DESIGN REVIEW COMMITTEE AGENDA

a) Z0083-23-D: Application for a Design Review permit to construct a new 15,360 square foot public library and to renovate an existing building (formerly Concord School) into a community center. ‡	Melissa Lord MLord@clackamas.us 503-742-4504
--	--

RECOMMENDATION TO THE DESIGN REVIEW COMMITTEE

File No. Z0083-23-D

4 NS SECTION THROUGH MEETING ROOM
A3.10 1/8" = 1'-0"

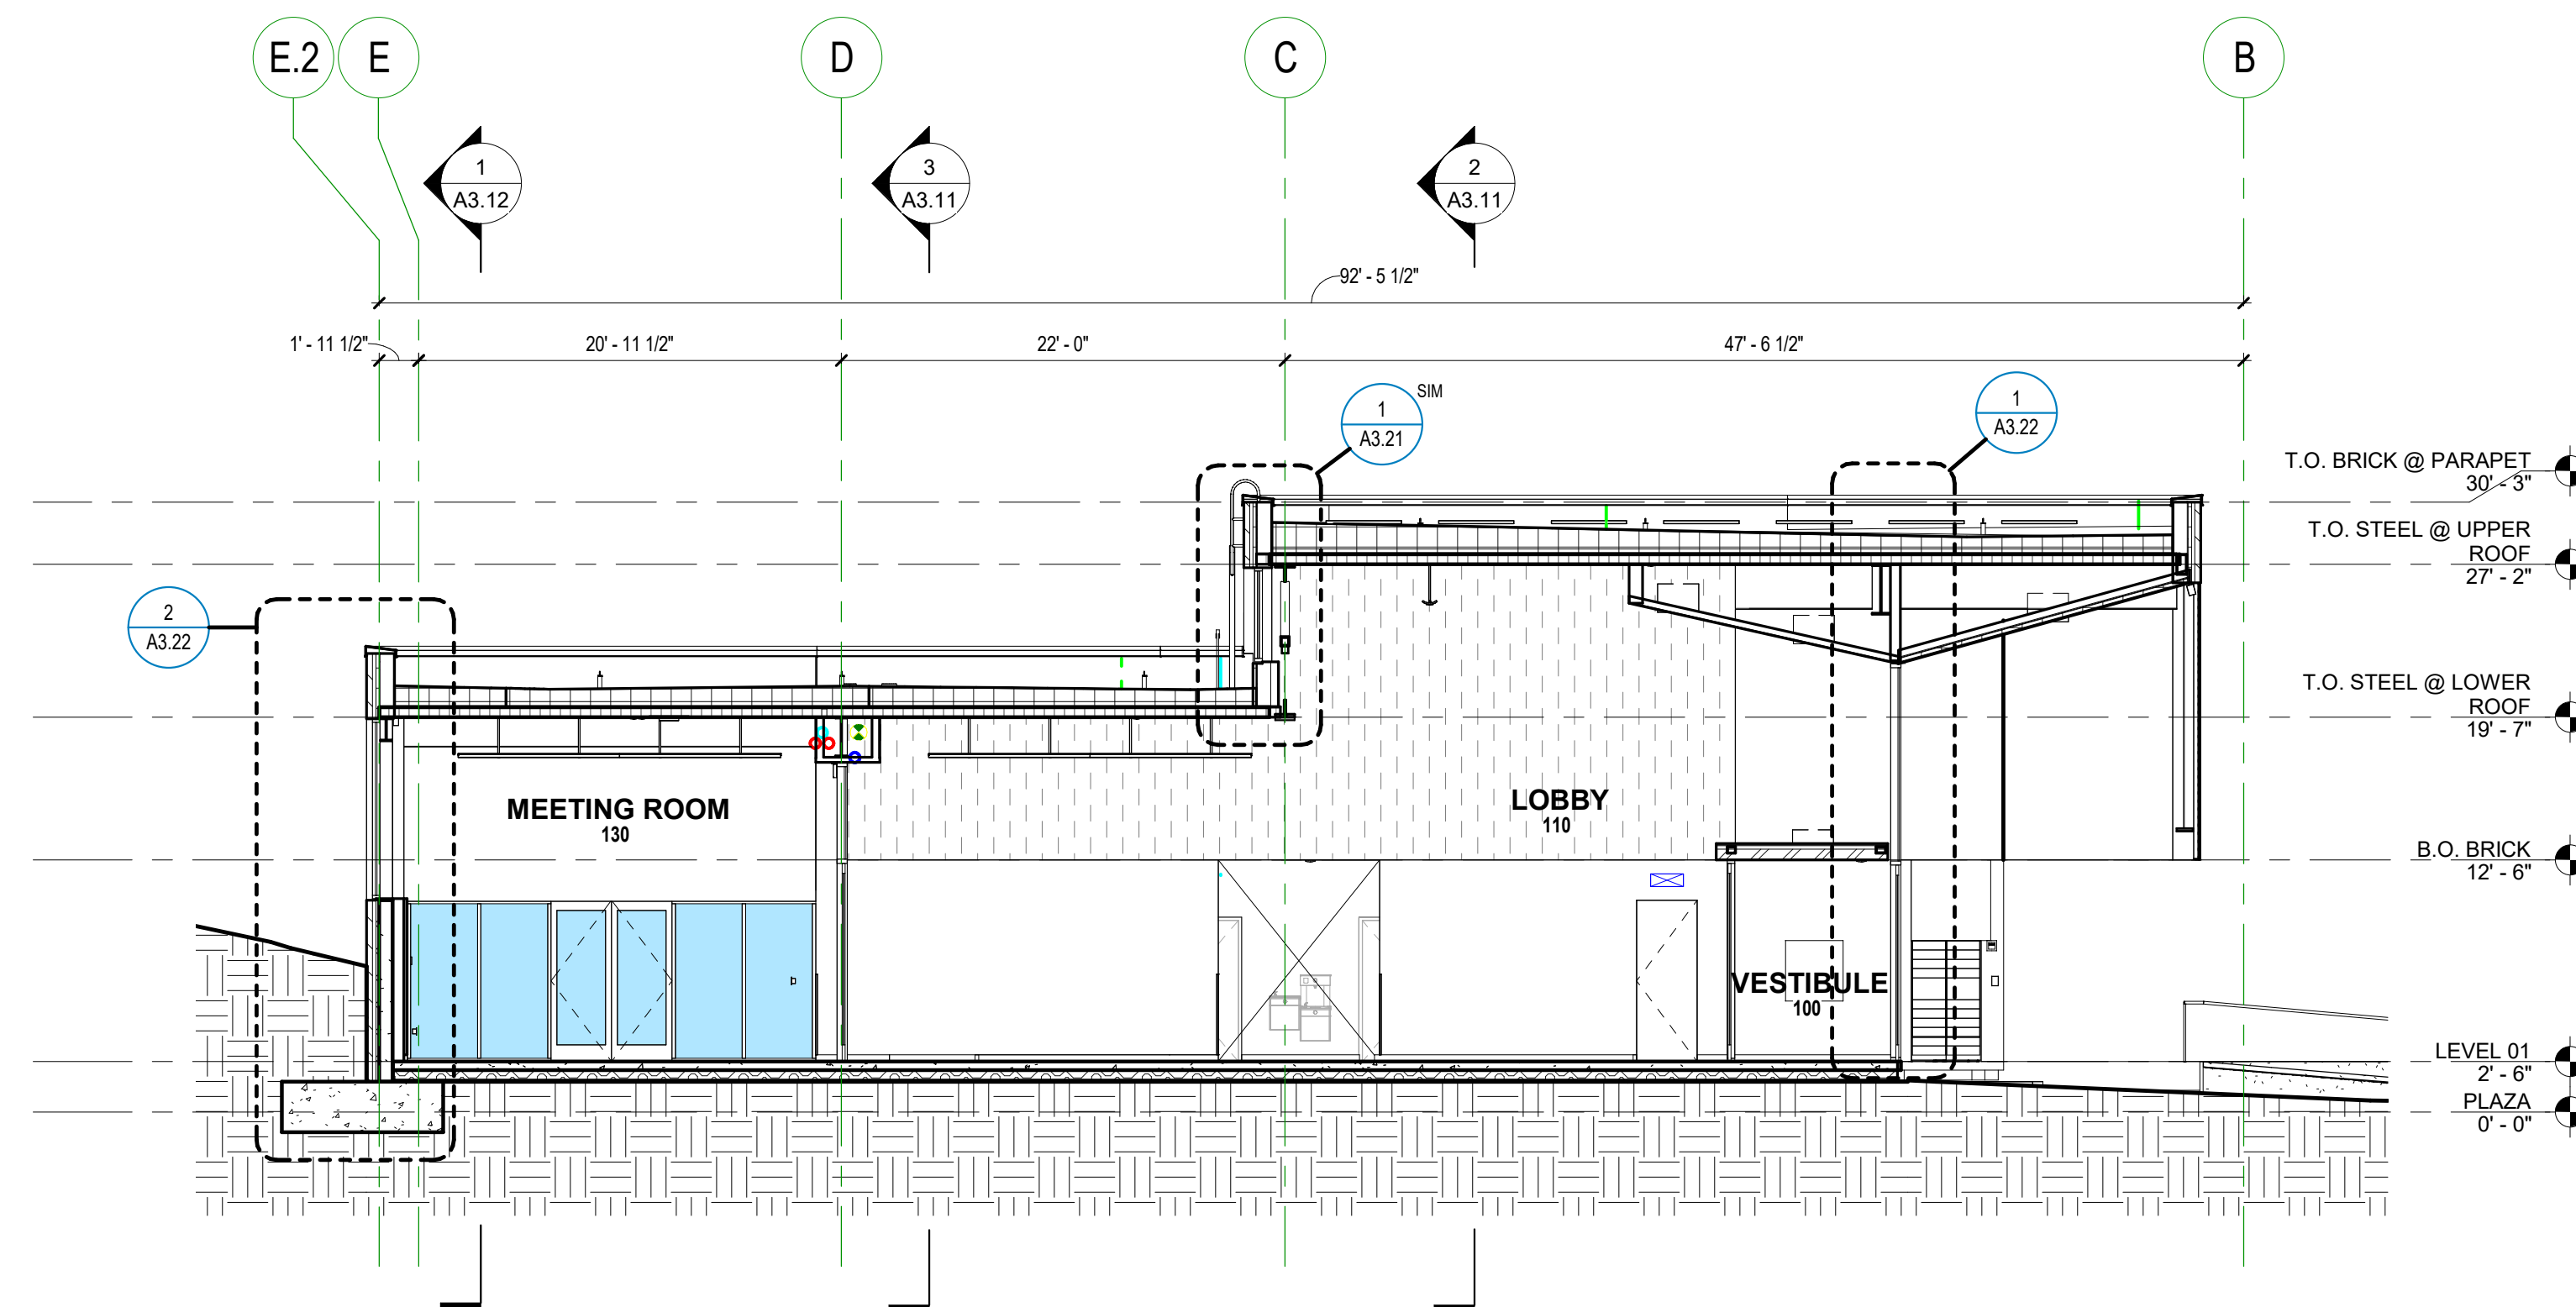
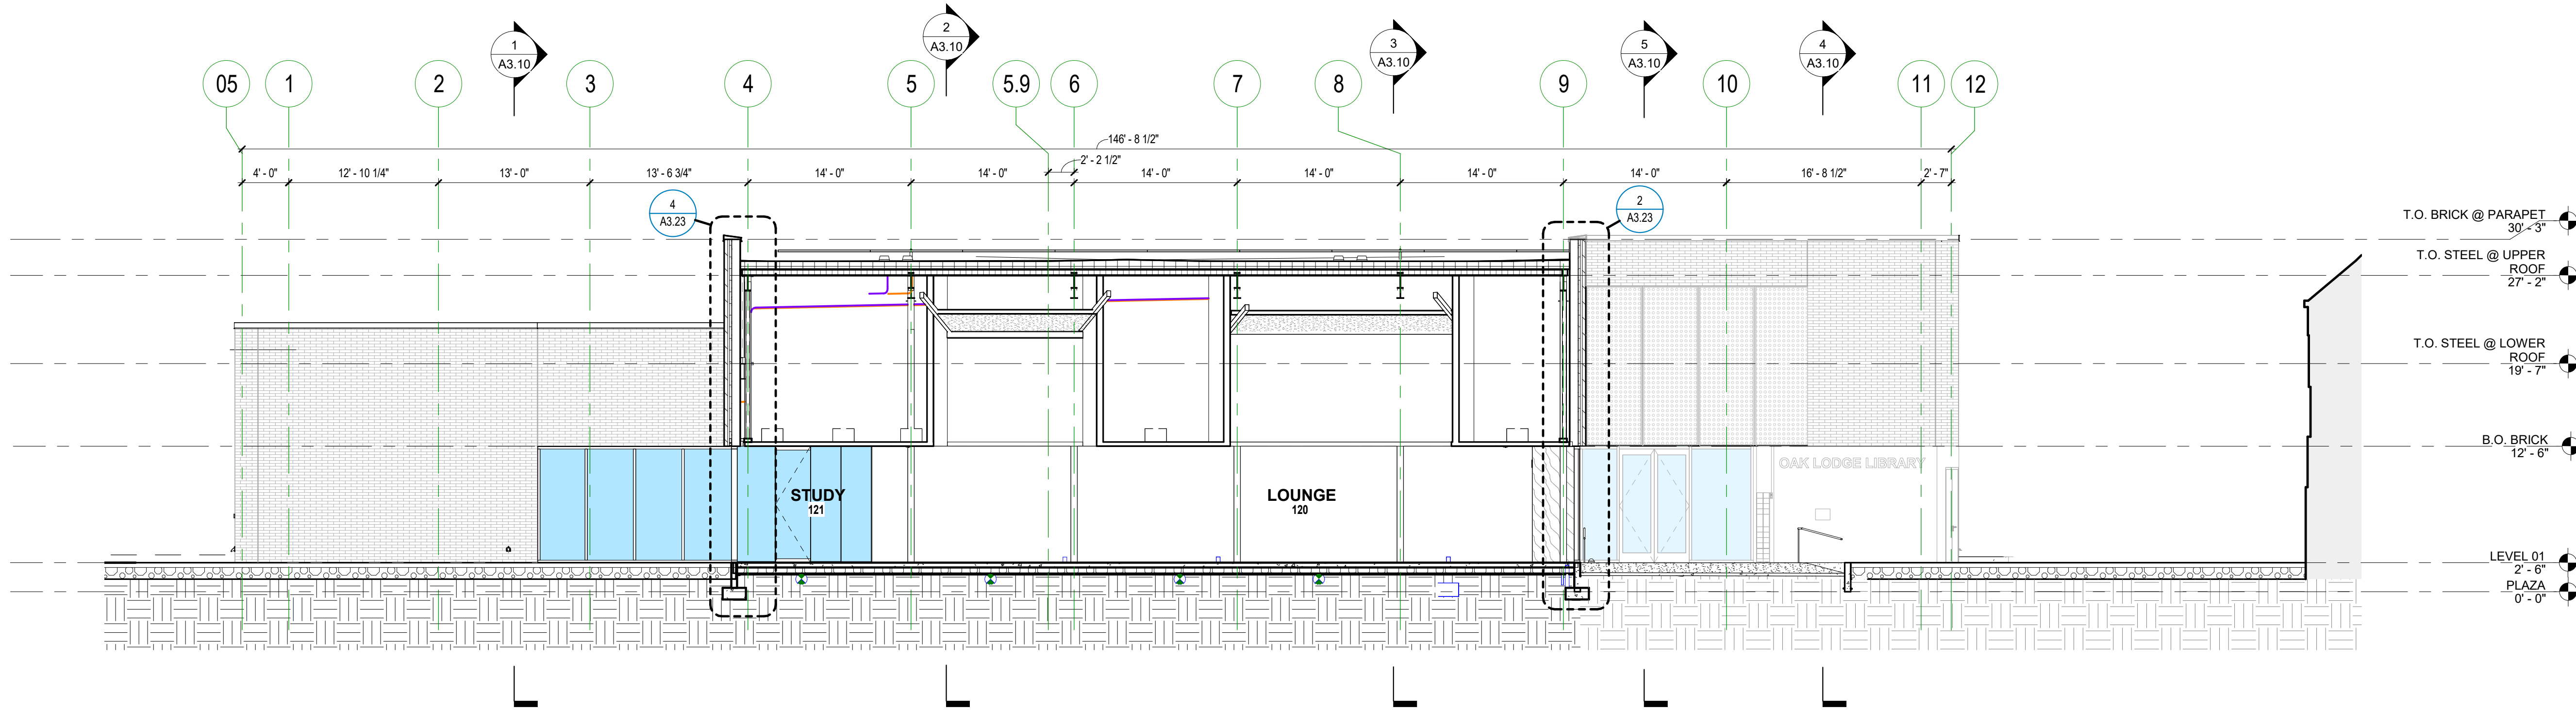
The new rooftop equipment on the library will be placed into a recessed well that will be screened by a parapet to ensure that none of the equipment is visible, as demonstrated on the plans submitted, including Sheet A3.10. The applicant's narrative states that "new mechanical units will be added to the community center roof that will be smaller than the existing units and will be pushed back from the roof edge as far as possible to obscure them from sight. Two new ground-mounted mechanical units will be placed on the east side (rear) of the community center and will be partially screened by the new trash enclosure and existing building."

1 | ENLARGED EXISTING & DEMO PLAN - TRASH ENCLOSURE
CC A0.81 1/4" = 1'-0"

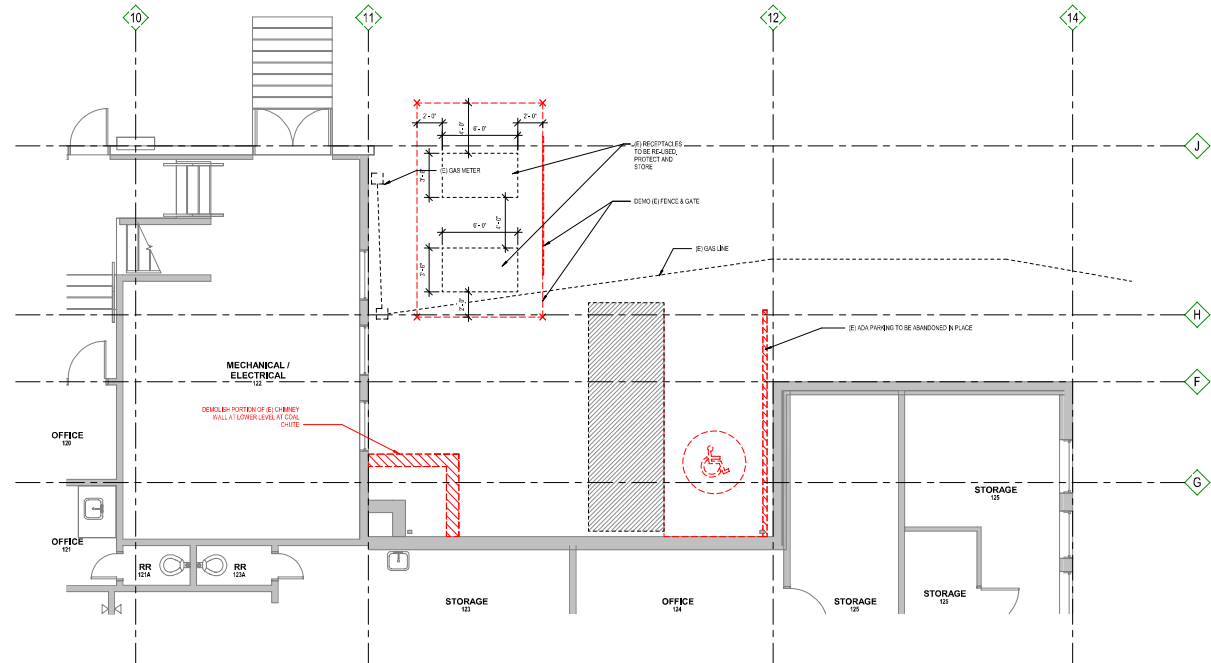
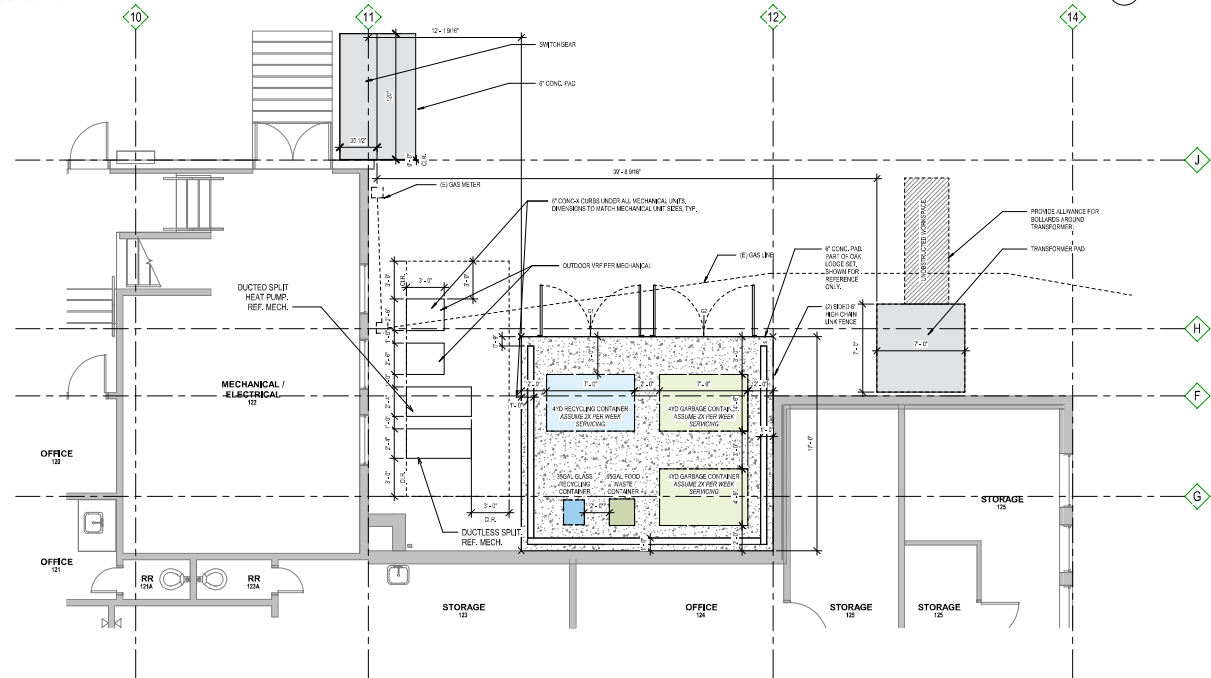
Subsection 1005.03(J) requires that ground-mounted mechanical equipment be screened by ornamental fences, screening enclosures, or landscaping that blocks at least 80% of the view. Staff finds that the proposed trash enclosure will screen the majority of the new mechanical units shown on Sheet CC A0.81 from Concord Rd.
